# PERMIT

SEWAGE DISPOSAL SYSTEM

MARYLAND STATE DEPARTMENT OF HEALTH

RE: Building Permit Application  
Serial Number: 37772  
Proposed Addition  
8210 Murphy Road

SCALE 1" = 100  
FEET & BOUNDARY

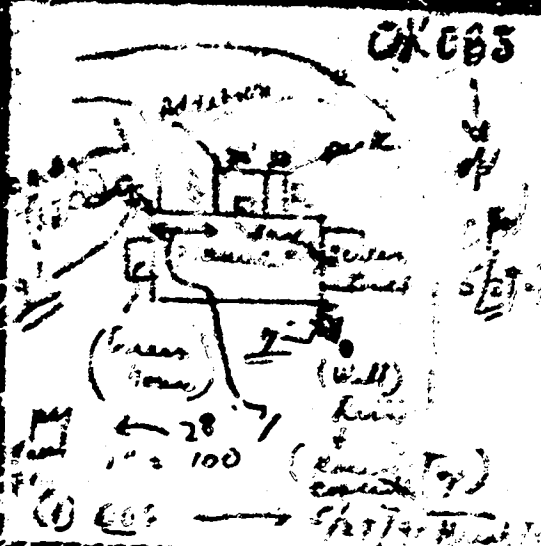
SULLY, CALICO  
✓ NO ACCESS TO PUBLIC SEWER  
② SUNDOWN (AND) DASH MOST ONLY  
NO INCREASE IN LIME ROLL AREA  
STILL NEED TO LOCATE TANK,  
HEALTH DEPT WILL RECOMMEND,  
DUT NOT REQUIRE,  
ADDITIONAL TRENCH CAPACITY  
5/23/91  
Will
